CARD No. 44

Engineered Barriers

44.A.1 BACKGROUND

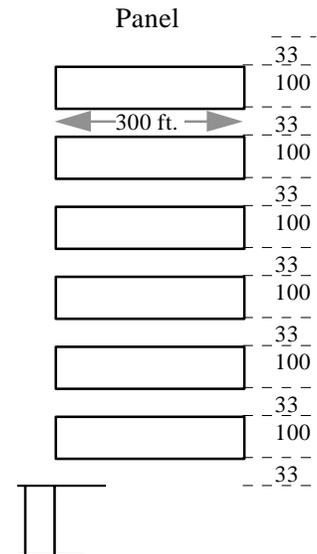
Calculation of linear feet of waste stack per panel

- Each Disposal Room is 33 feet wide and 300 feet long
- Each pillar is 100 feet wide
- Linear feet of Disposal Rooms/panel

$$\frac{300 \text{ feet}}{\text{Room}} \times 7 \text{ rooms} = \frac{2,100 \text{ feet}}{\text{panel}}$$
- Linear feet of Panel Access Drift

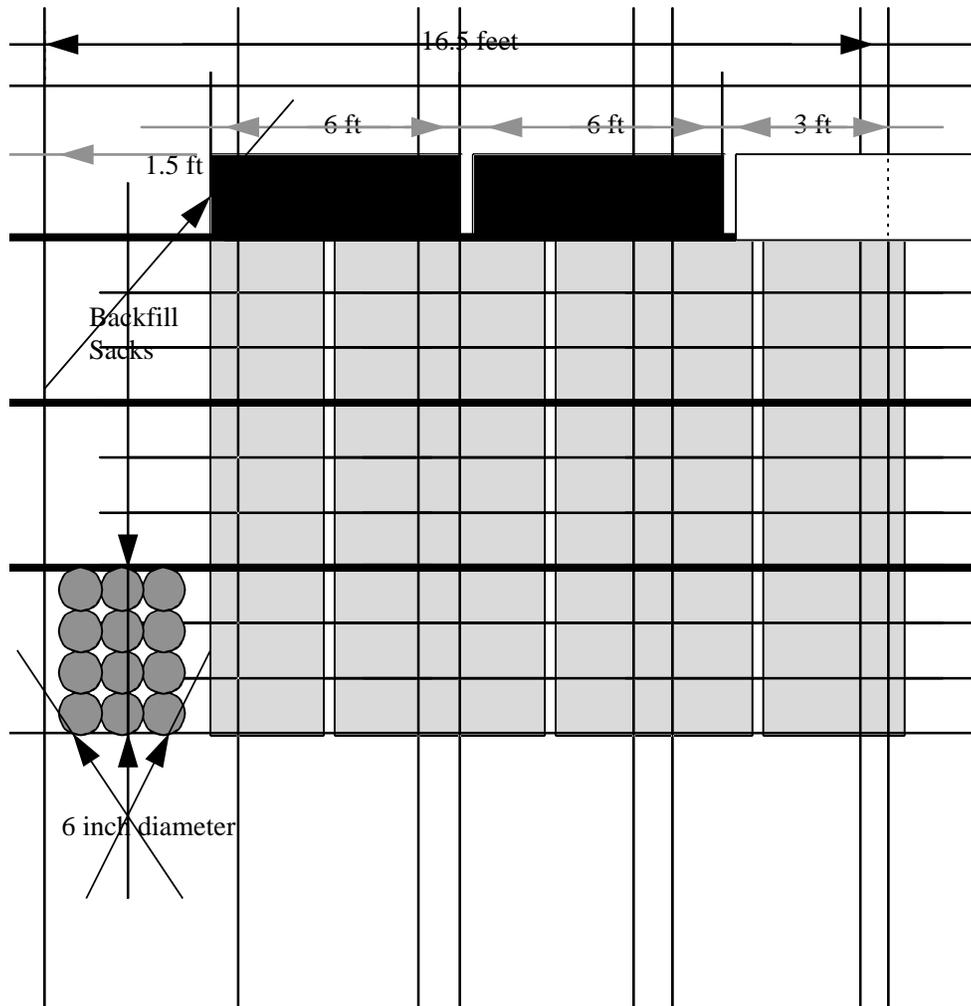
Weight of MgO in mini sacks = 25 lbs
There are 6 mini sacks per 7 pack of drums
There will be 12,000 7 packs per panel

$$25 \text{ lbs} \times 6 \times 12,000 = \frac{1,800,000 \text{ lbs of MgO}}{\text{Panel}}$$

$$\frac{1,800,000 \text{ lbs}}{2,000 \text{ lbs/tons}} = \frac{900 \text{ tons} \times 10}{\text{Panel}} = \mathbf{9,000 \text{ tons of MgO in Repository}}$$

DOE assumed $\frac{800 \text{ tons}}{\text{Panel}}$ or $\frac{8,000 \text{ tons}}{\text{Repository}}$
